Title: Advisory Committee on Reactor Safeguards

Fukushima Subcommittee Meeting

Mitigation of Beyond Design Basis Events

Date: Friday, April 22, 2016

- GMRS is bounded by the SSE at frequencies
 1 Hz and greater
- Additional evaluation is unnecessary
- The FLEX strategies can be implemented as designed and no further seismic evaluations are necessary

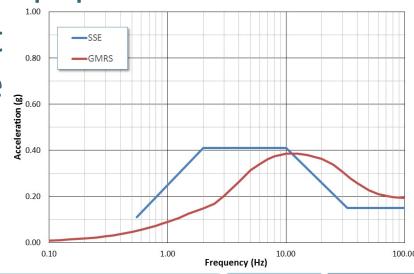
1	don't see them on the screen here, but you've got
2	them in front of you? Okay. All right.
3	So for Path 1, as I mentioned, these are
4	the plants where the GMRS is bounded by the SSE at
5	all frequencies. For these plants, additional
6	evaluation under Appendix H is unnecessary. FLEX
7	strategies can be implemented as designed without
8	any further seismic evaluations. So yes?
9	MEMBER RICCARDELLA: In that you
LO	referred to except for narrow band exceedances? Can
L1	you help me with what you mean by narrow band
L2	exceedances?
L3	MR. RICHARDS: Yes. Narrow band
L 4	exceedances would be a small frequency range where
L5	there is a possibility of a minor exceedance, and in
L 6	the NTTF 2.1 evaluations, those plants are screened
L7	out from doing any more work because those narrow
L8	band exceedances are not really damaging.
L9	MEMBER RICCARDELLA: Okay.
20	MR. RICHARDS: So the same screening
21	philosophy is being used here in the mitigation

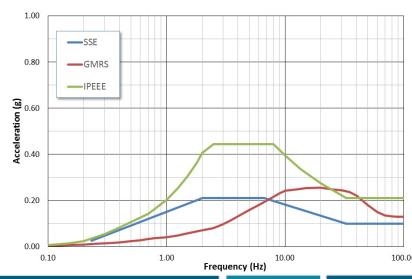
Given the fact that the plant has probably changed, that the reason that I did the IPEEE was to somehow quickly identify things that I might call a vulnerability, but somebody else might not call a vulnerability, how do I know that those models are sufficiently broad and deep for me to make these types of conclusions today?

MR. MAUER: But obviously, that set of plants has gone through and justified to the NRC for the purpose of the 50.54(f) response that the IPEEE is adequate, and that has been reviewed by the NRC and accepted, so I have to point back to that

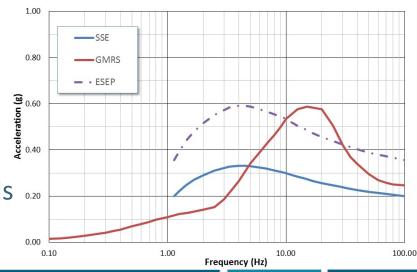
really a three-step process. The first relies on the result of the expedited seismic evaluation process, so it would take that process and that evaluation which was done, and basically it was performed as a snapshot, and that would continue under a mitigating strategy, so we would change the purpose of what we did there to leverage it for this effort going forward.

Ιt also relies on а qualitative assessment of certain SSCs based seismic on Those SSCs and the assessment experience. provided in Appendix H under Step 2. And then for the remaining FLEX SSCs identified in Step 3, such as the FLEX storage building, hall pass, et cetera. It will perform a quantitative assessment of those SSCs and look at any modifications that might be necessary for FLEX, so it's a three-step process that relies on those three parts as described in Appendix H in more detail.
